CITY OF MEXICO BEACH
4TH STREET STORMWATER IMPROVEMENTS PROJECT

**ADDENDUM NO. 5
REQUESTS FOR INFORMATION**

Issued September 15th, 2025

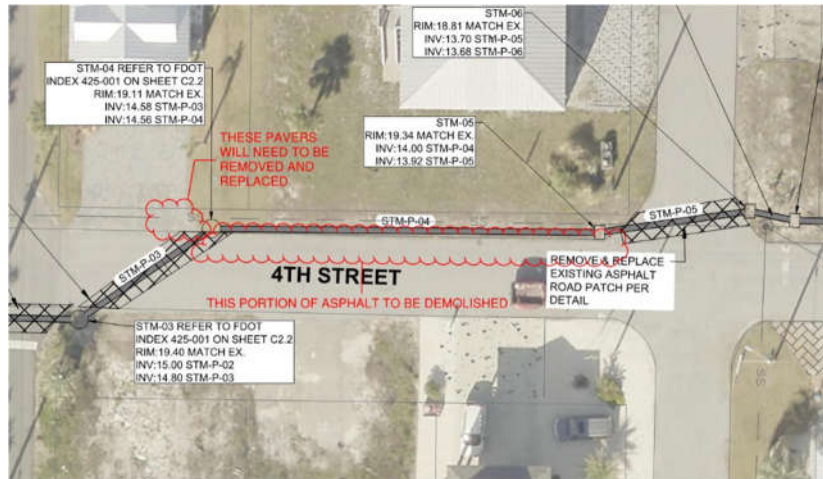
7. Structure STM-09 notes to “Connect existing 12” pipes to proposed structure.” The details for this structure call EX-STM-P-581 to be connected to this structure which is labeled as 30” HDPE on the stormwater pipe table. Can you clarify the size of EX-STM-P-581?

City’s Response to Request for Information Question No. 7: The size of EX-STM-P-581 has been updated on the Stormwater Pipe Table to 30”. Refer to revised sheet C1.0. The structure has been changed to a Type D – refer to revised Bid Form and Measurement & Payment Section.

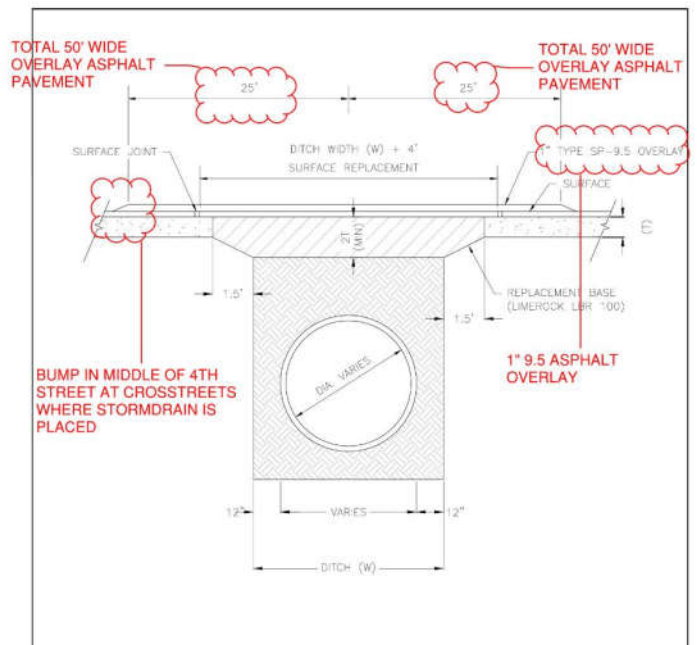
9. For the length of stormdrain shown in the image below, the excavated trench depth will likely be between 5.5' - 7' deep to allow for the bedding gravel and suitable foundation thicknesses. With the close proximity of the installed stormdrain plus the required trench widths to allow for the proper amount of cement stabilized sand backfill and trench shoring, our excavation will definitely go into the roadway and require removal and replacement of asphalt pavement through this section. Please correct the square yardage quantities to allow for asphalt removal and replacement for this section of pipe installation as well.

City's Response to Request for Information Question No. 9: The plans have been modified to avoid damages to the driveway and asphalt.

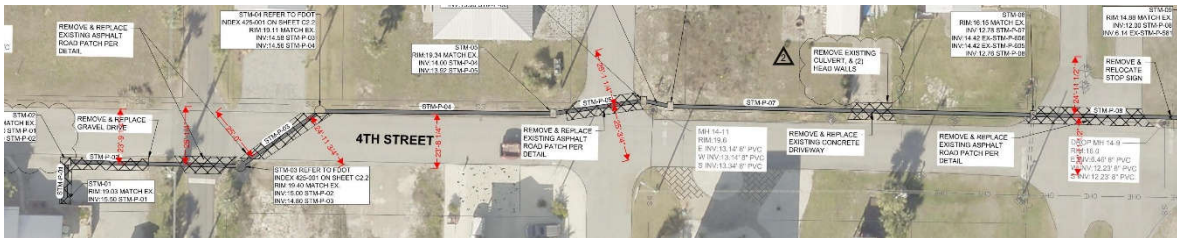
11. There is no bid form line item for the overlay asphalt and the square yardage indicated in the removal and replacement of asphalt is not sufficient to cover the overlay quantities. If no changes are made, where in the bid form should we include the cost for this work?

City's Response to Request for Information Question No. 11: See new City Detail on sheet C2.1 included in the revised drawing set. Bid Item # 9 includes Cut and Patch Asphalt per the Measurement & Payment Section 01150.

THIS SHEET NOT VALID FOR CONSTRUCTION WITHOUT COMPLETE SET OF PLANS. SEE GENERAL NOTES FOR MASTER LEGEND.
Sheet No.
60.2

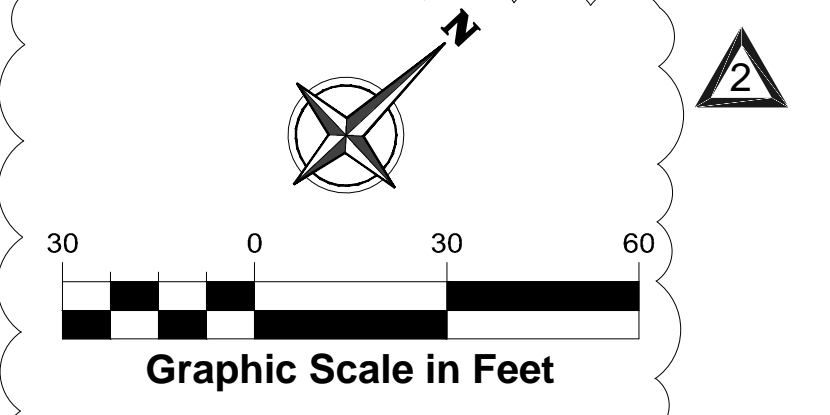
2. C0.2 shows the existing conditions and existing drainage system. With majority of the proposed drainage system overlapping the existing, I am assuming the existing system is to be demoed. Can you clarify the City's intent of the existing drainage system?

3. If the existing drainage system is to be demoed, can you provide the following information?
 - What pipe runs and inlets are to be removed
 - Inlet types and or sizes
 - Pipe sizes and material
 - Asphalt quantities for existing pipe runs across roadways
 - What line item the demolition of the existing system is to be included in

City's Response to Request for Information Question No. 2: There is no existing stormwater system except what is specifically called out. See revised sheet C0.2.

City's Response to Request for Information Question No. 3: There is no existing stormwater system except what is specifically called out. See revised sheet C0.2.

4TH STREET IMPROVEMENTS PLAN
4TH STREET STORMWATER IMPROVEMENTS
 MEXICO BEACH / BAY COUNTY / FL
 THIS SHEET NOT VALID FOR CONSTRUCTION WITHOUT COMPLETE SET OF PLANS. SEE GENERAL NOTES FOR MASTER LEGEND.
 Sheet No. **C1.0**

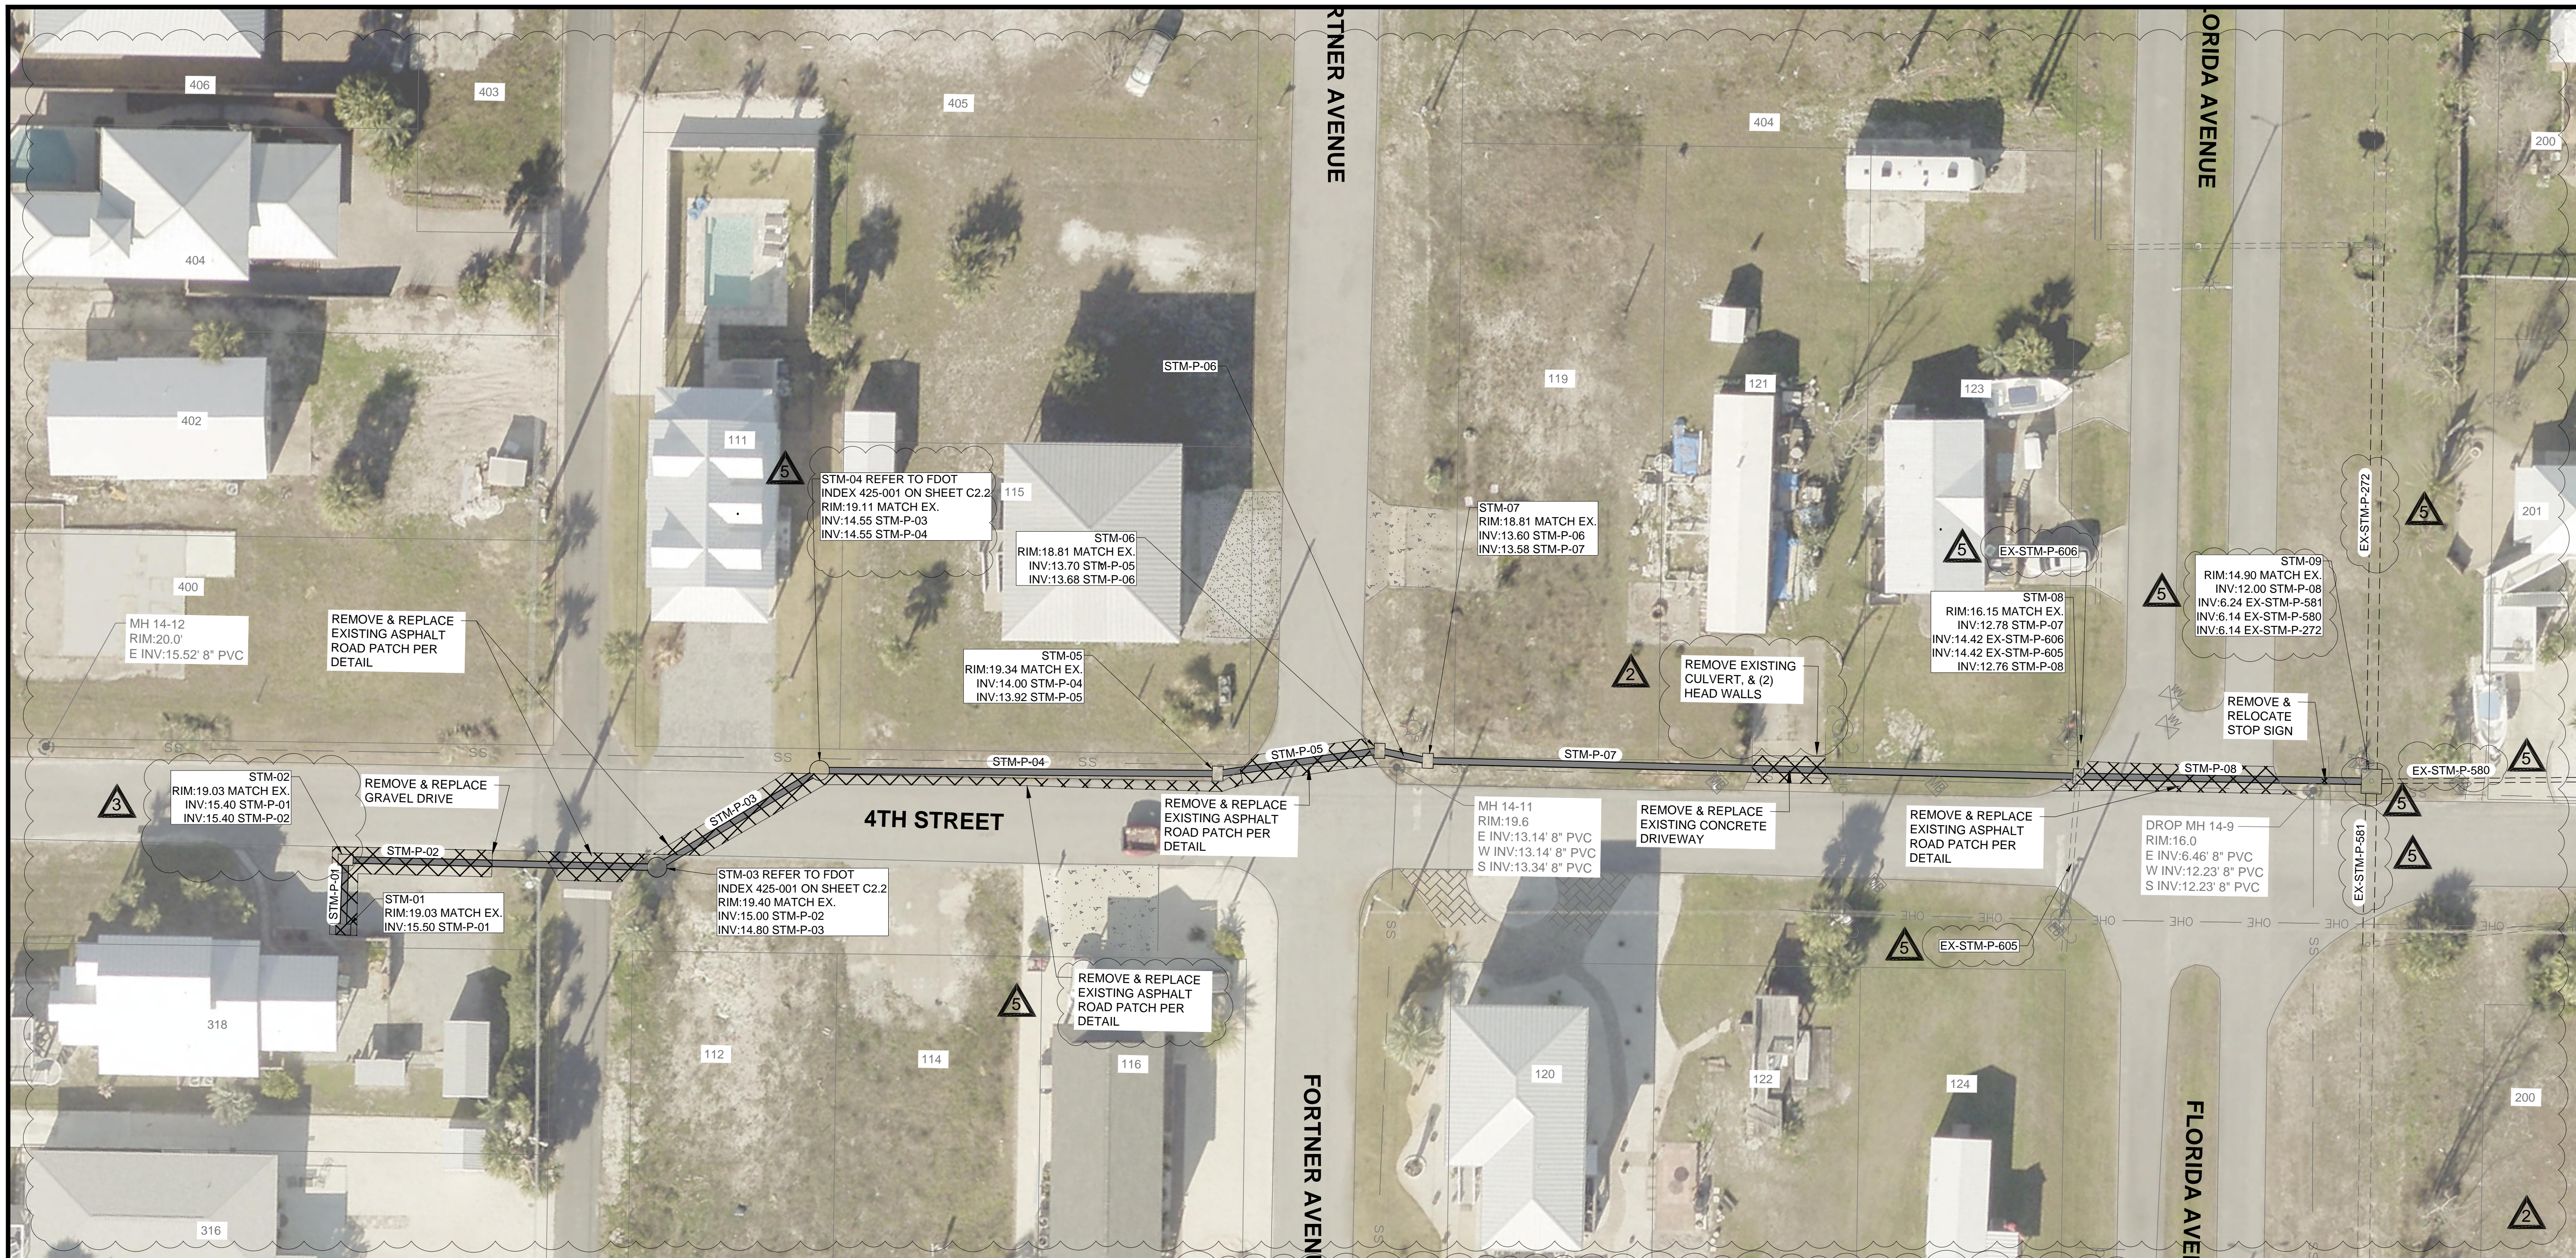
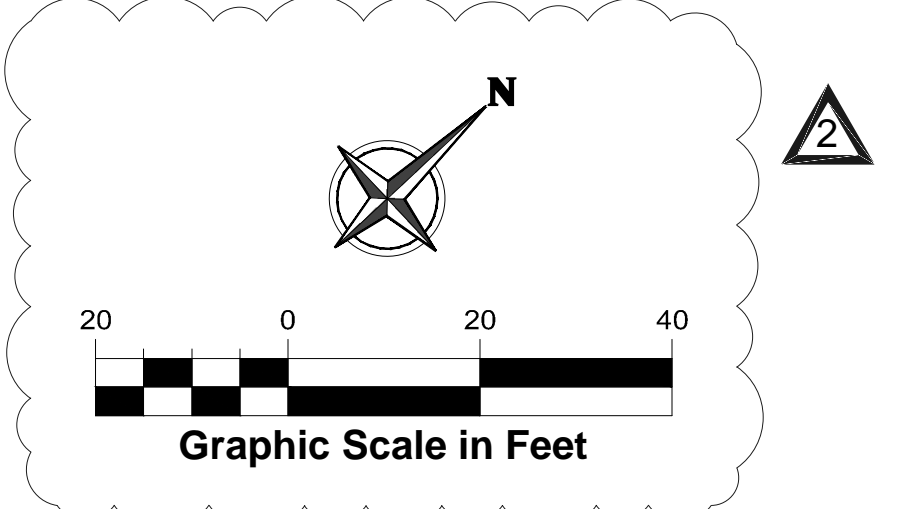
4. There is a run of pipe shown on sheet C0.2 connecting to STM-06 crossing 4th street. Based on the given inverts of this inlet, I am assuming this pipe run to be EX-STM-P-272. This pipe run is not shown on the proposed plans. Is this pipe to be demoed? If so, what is the pipe size and where is the termination point of this run as no inlet is shown on the southeast side of 4th St?

5. Structure STM-07 notes to “Connect existing 12” pipes to proposed structure.” There are no existing pipes shown on the plans or in the structure detail to be connected to this inlet. Can you clarify this?

6. Structure STM-08 notes to “Connect existing 12” pipes to proposed structure.” The details for this structure call EX-STM-P-606 and EX-STM-P-605 connecting to this inlet. The stormwater pipe table does not provide the sizes of these pipes and only one existing run is shown on the plans connecting to this structure which is not labeled. Can you clarify that there are two existing pipes to connect to this structure and the sizes of these pipes?

City's Response to Request for Information Question No. 4: That run of pipe is existing. See revised sheets C0.2 & C1.0.

City’s Response to Request for Information Question No. 5: Refer to revised sheet C1.0. There are no existing pipes connecting to this structure; only the new pipes as shown on C1.0.

City’s Response to Request for Information Question No. 6: There are two existing pipes, one entering the inlet and one leaving the inlet; both pipes are 12”. See revised sheet C1.0.
